Subject: Responses to January 20, 2010, Department of Toxic Substances Control
Comments on Cleanup Plan for Pits in Polychlorinated Biphenyl Site Building 386
AL#01 in Investigation Area C2, Lennar Mare Island, Vallejo, California

**Response to Comments Regarding the
Cleanup Plan for Pits in PCB Site Building 386 AL#01, Investigation Area C2, dated October 6, 2009
from
Department of Toxic Substances Control on January 20, 2010**

FIGURE 3
REVISED PCB SITE BUILDING 386 AL#01
PIT 3 PROPOSED REMOVAL AREAS
AND TOTAL PCB CONCENTRATIONS
 LENNAR MARE ISLAND, CALIFORNIA

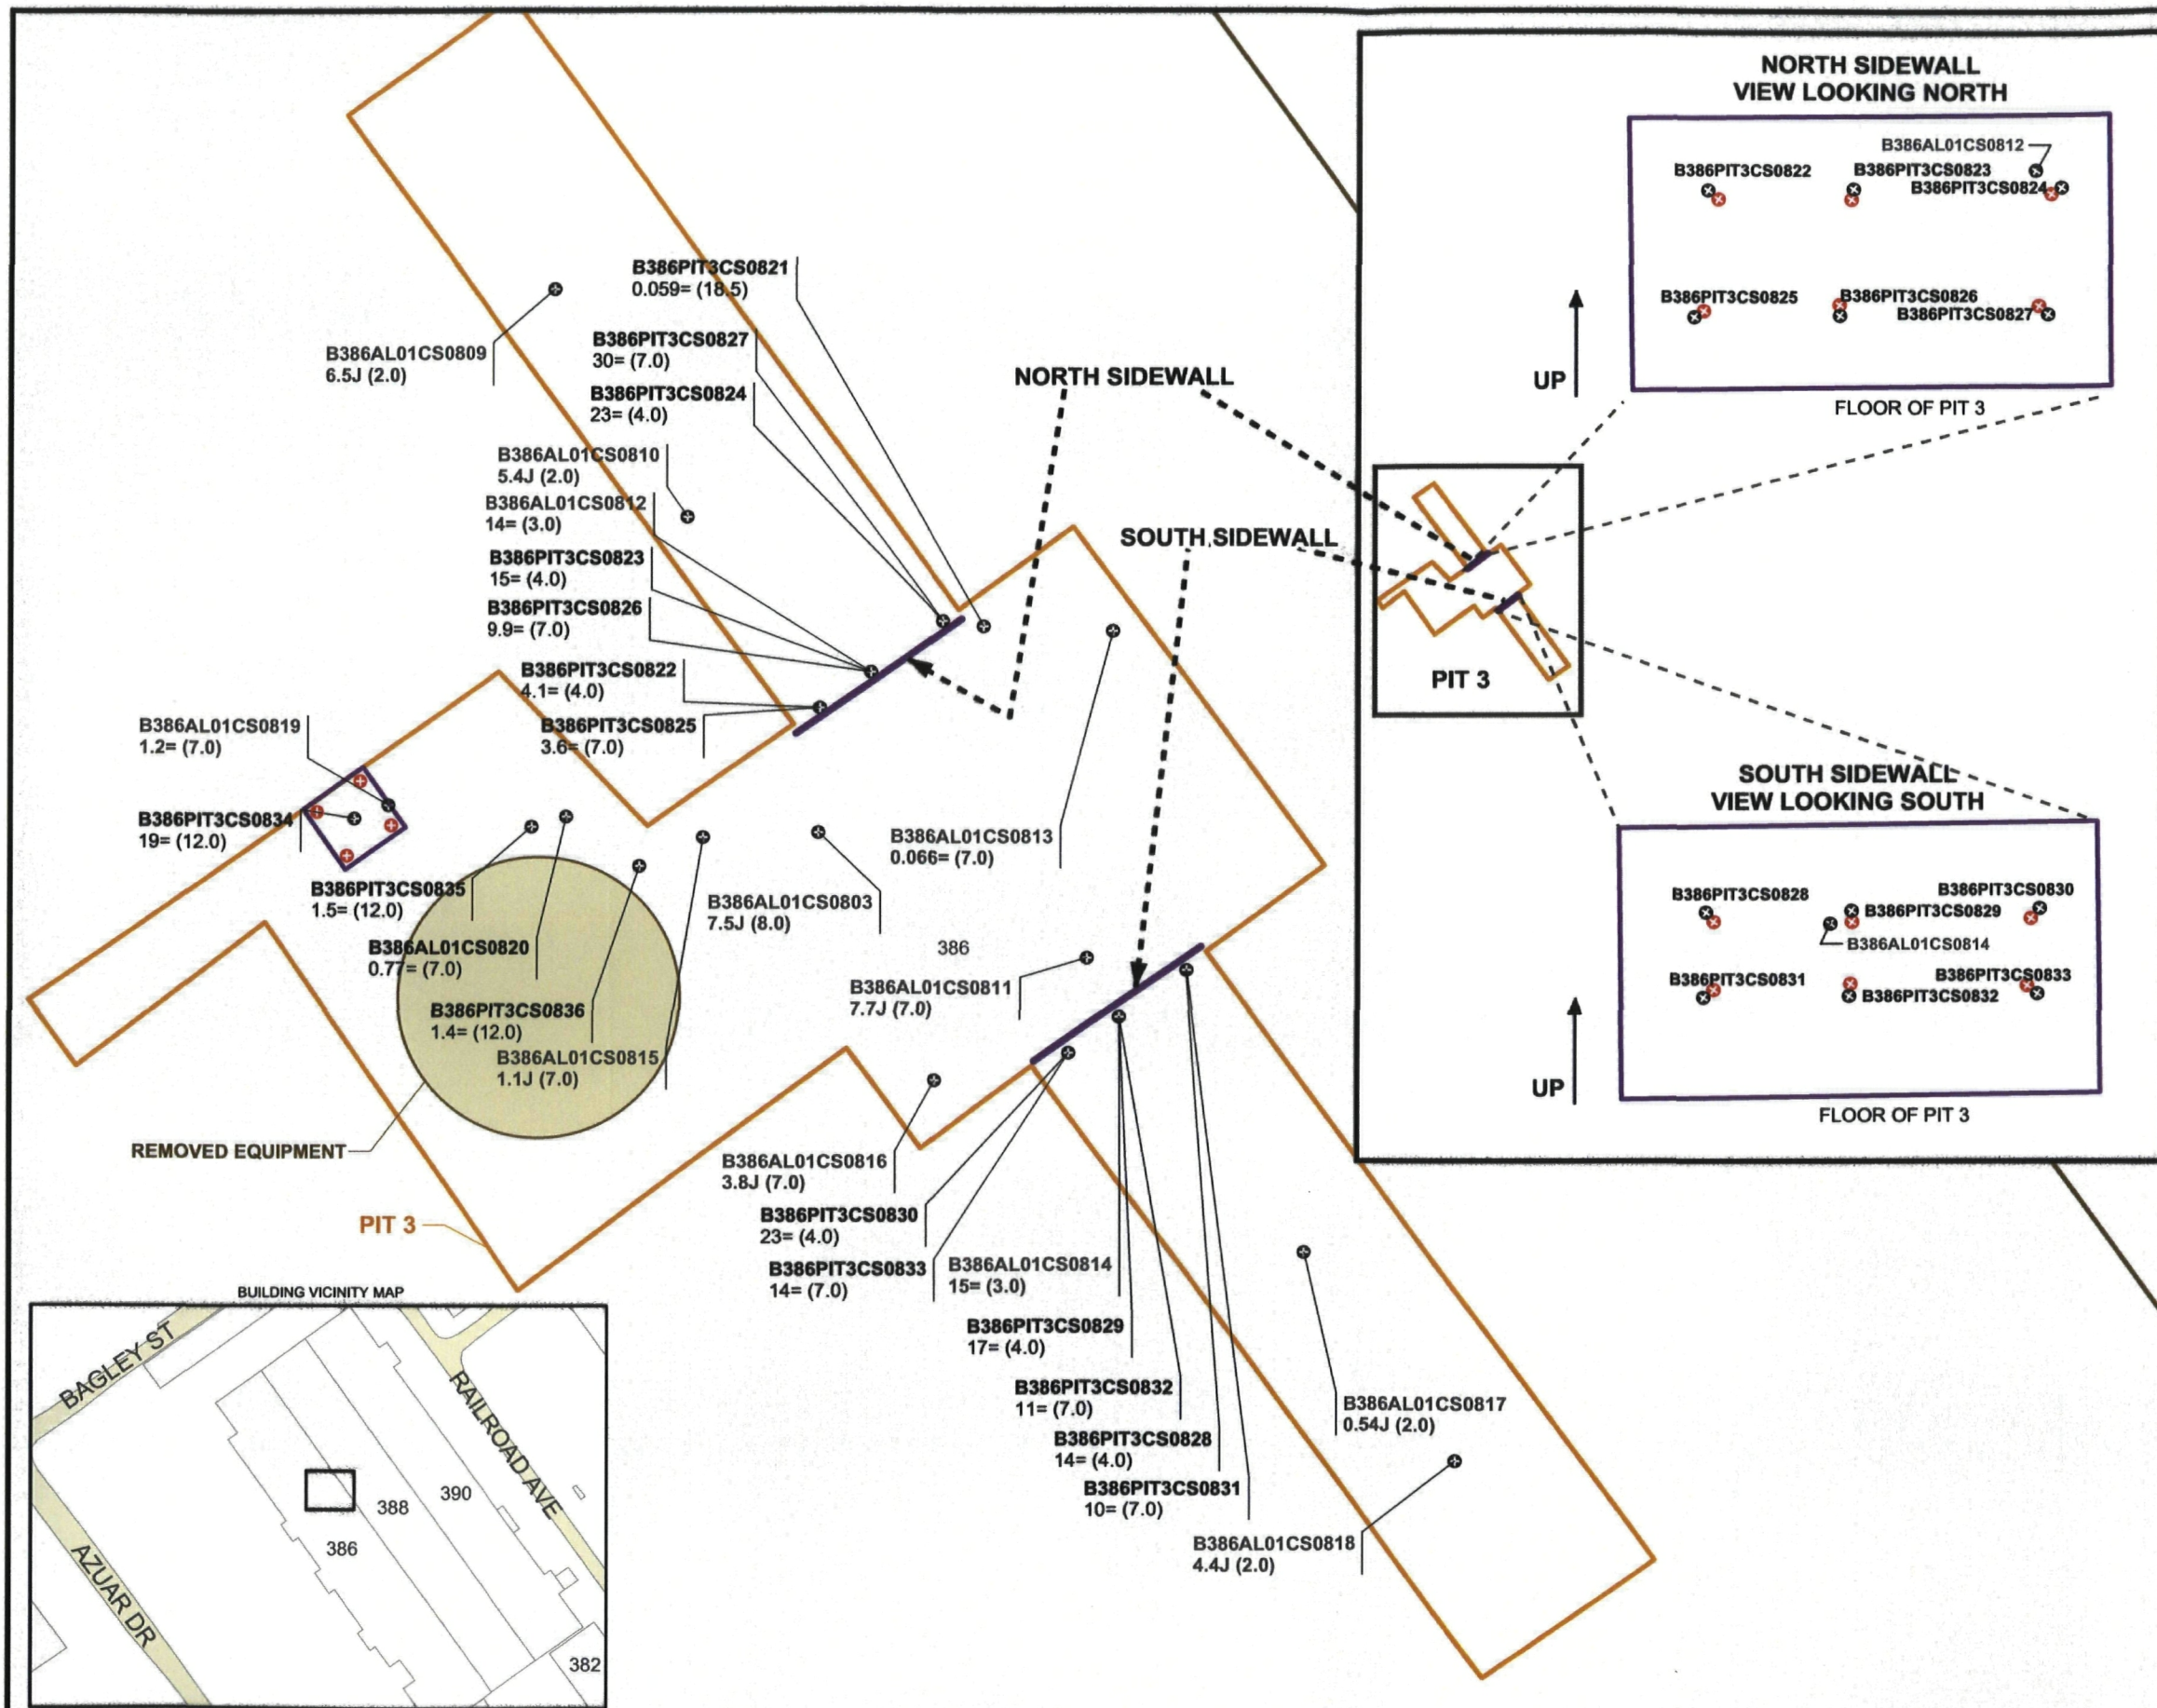
5.		Figure 3. a. The sidewall representations do not show the samples at the depths indicated in the figure. For example, sample B386AL01CS0814 is shown between samples B386PIT3CS0829 and B386PIT3CS0832. However, within the figure, sample B386AL01CS0814 is labeled with a depth of 3 feet, sample B386PIT3CS0829 is labeled with a depth of 4 feet and sample B386PIT3CS0832 is labeled with a depth of 7 feet. Similar problem encountered on the north side wall for the middle sample.	a. Revised Table 1 is attached. b. Revised Figure 3 is attached to show the correct sample locations. c. Revised Figure 3 shows samples IDs and concentrations collected prior to pressure washing in gray font.

No.	Section	Comments	Responses
		<p>b. On the sidewall representations, the sidewall, samples B386PIT3CS0828 and B385PIT3CS0830 appear to have switched locations, as do the lower two samples (B386PIT3CS0831 and B386PIT3CS0833).</p> <p>c. Samples collected both before and after pressure washing are included in this figure. If an area was pressure-washed and the sample result shown on the figure was collected prior to pressure-washing, an asterisk or some other identifier should be used to qualify the data.</p>
